Office Action Summary

10/749,771

DETAILED ACTION

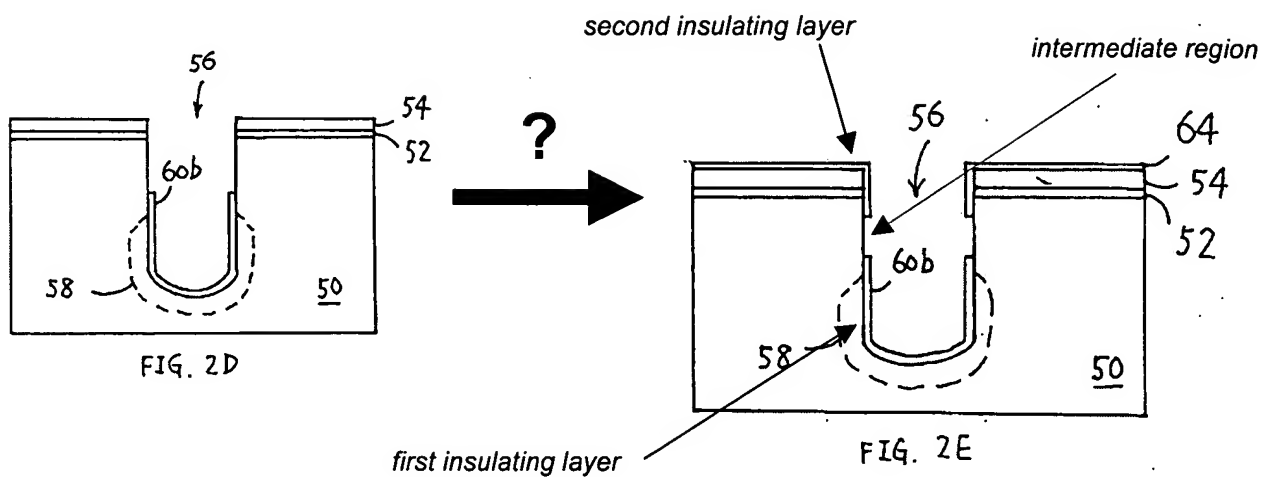
2. The specification is objected to for a lack of adequate explanation of how the transition from Fig. 2D to Fig. 2E is performed in accordance with the claimed invention, the transition from Fig. 2D to Fig. 2E being an essential part of enablement of the claim phrases: "the second insulating layer *being separated* from the first insulating layer *by an intermediate region*" (i.e. claims 1-11) and "forming a first insulating layer *up to a lower level* of the intermediate region...and forming a second insulating layer *down to an upper level* of the *intermediate region*" (i.e. claims 13-16).

The practice of claims 1-11 and 13-16 requires practice of the transition from Fig. 2D to 2E, without undue experimentation. Figs 2D and 2E are repeated here for clarity:

The written description for enablement of the claim phrases identified above consists of a single “example” as being an “ALD” process to form layer 64 (at p. 7, [026]), such that the layer is controlled to extend only part way down the trench 56 sidewalls, as depicted in Fig. 2E.

That is, ALD is used to form layer 64 with a “separation” seen as a gap between the “first and second insulating layers” at the “intermediate region” (claims 5, 10 & 15).

Yet, applicant does not explain how an ALD process is used to form layer 64 as depicted in Fig. 2E (as is claimed) because ALD is known to be a “conformal” process:

That is, in the prior art, ALD would not readily be utilized to deposit a layer like 64 in Fig. 2E, without further instruction of how to use ALD *contrary* to its well-known benefits [i.e. applicant doesn't explain how applicant is using ALD for selective deposition on trench sidewalls rather than for conformal deposition over a contiguous surface inside the trench].

Particularly rejected claims 5, 10 and 15 are puzzling in view of evidence in the prior art that ALD is a *conformal process*. If layer 64 can not make its way to be evenly conformally deposited inside the trench as in Fig. 2E, then the first insulating layer would have problems with being conformally deposited by any method:

Perhaps applicant has omitted details of modifying an ALD process to perform a controlled selective sidewall deposition of layer 64 as seen in Fig 2E. Perhaps applicant has omitted disclosure of a sacrificial layer in forming layer 64. Perhaps applicant has omitted disclosure of masking in forming layer 64.

Correction and/or explanation are required.

Correction and/or explanation are required.

FIG.6

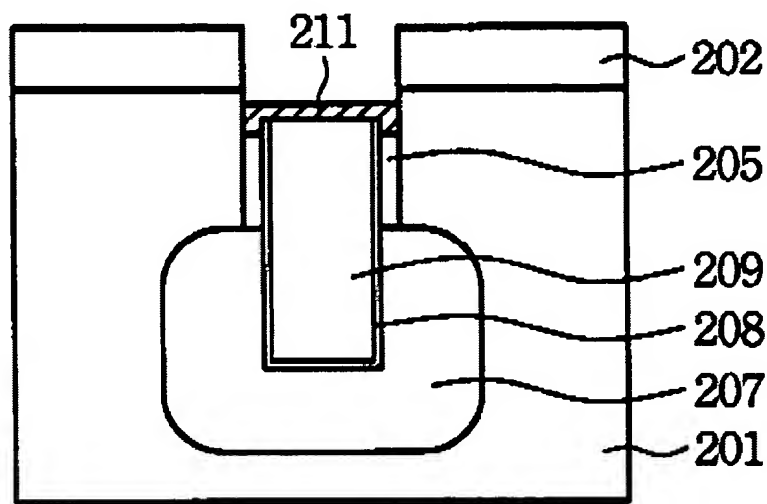
Regarding claim 17, Fig. 6 shows a structure that anticipates:

17. A trench capacitor comprising:
 a trench (200 in Fig. 2) formed into a semiconductor substrate including a lower region and an upper region (e.g. 211, 208 and 209 are in the trench into substrate 201, the trench inherently having upper top and lower bottom regions),
 a first conductive region formed around the lower region of the trench (plate 207),
 a collar oxide (205) formed on and into ("into" per Fig. 3) sidewalls of the trench at an intermediate region between the lower region and the upper region (i.e. anywhere between top and bottom of the trench being an "intermediate region"),
 a dielectric layer (208) formed along the sidewalls of the trench up to a level above the collar oxide (205); and
 a second conductive region (209) formed up to the level (i.e. "up to" and "above").

Regarding claim 20, the dielectric layer (i.e. 208 in Fig. 6) is formed "up to a top level of the collar oxide (205)," because 208 is "up to a top level of 205" and extending a little further to also be "above" as well, as is claimed in claim 17 from which claim 20 depends (see item 1 above).
